## **The Star - MOD 13 (MP08\_0098 MOD13)**

### **Response to City of Sydney comments to the Response to Submissions**

Figure 16. Proposed 100 Year ARI Flood Depth on Pyrmont Street (flood depth<100mm not shown).

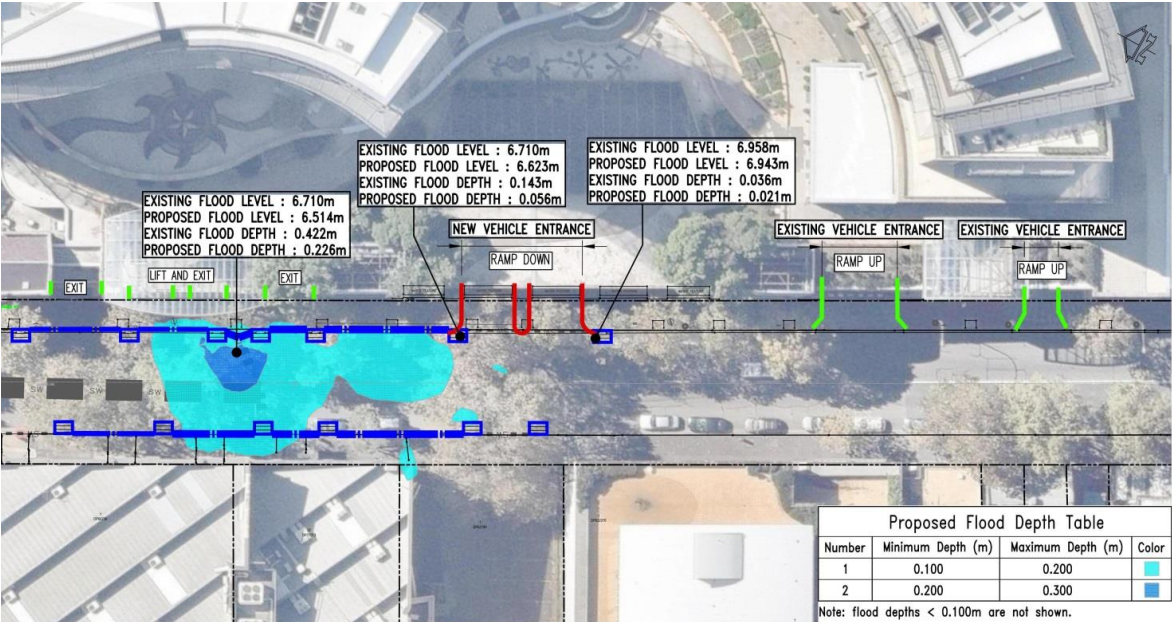
Nevertheless, it is expected that the revised flood impact assessment addendum prepared by TTW dated 07.11.2018 should demonstrate that the proposed and existing FFL comply with Council's Interim Floodplain Management Policy, and include a plan showing the FFL, existing kerb and 1%AEP, and PMF.

Plans that show the extent of flooding, levels and depths are included below (refer to section 4.3 - pages 19 and 20 of the January 2018 Flood Impact Assessment and refer to page 5 of the November 2018 Flood Impact Assessment Addendum):

At the trapped low point in Pyrmont Street, the 1% AEP (100 year ARI) flood level is 6.51m AHD. The Ground Floor level is 8.50m AHD and achieves the Flood Planning Level requirement. The new entrance to the basement car park on Pyrmont Street is above the top of kerb and 1% AEP flood level and will be protected up to Flood Planning level (1% AEP 0.5m) with the use of automatic self-closing flood gates.
